Technical Bulletin from Texas Access

New Accessible Parking Requirements in Effect in Texas TDLR Administrative Rule §68.104. Accessible Parking Spaces

Effective for projects registered with the TDLR on or after August 1st, 2020.
The requirements are NOT retroactive to projects registered with the TDLR prior to August 1st, 2020.

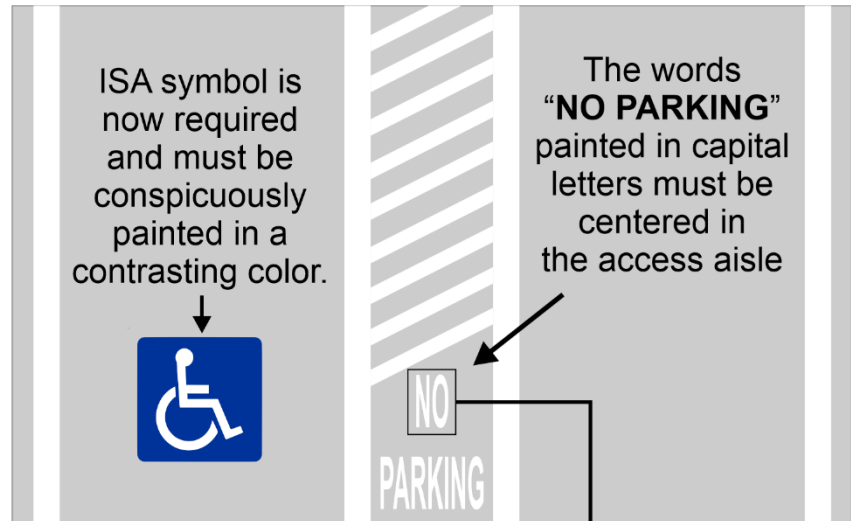
8" max. if a separate sign.

All signs must at minimum include the language "Violators Subject To Fine and Towing" in 1 inch min. high letters.

The parking consequences sign shall be 48" min. to 80" max. above the parking surface to the bottom of the sign.

Note: The height of the parking sign required by TAS Section 502.6 is 60" min. above the parking surface.

Signs must be mounted on a pole, wall, or free-standing board.
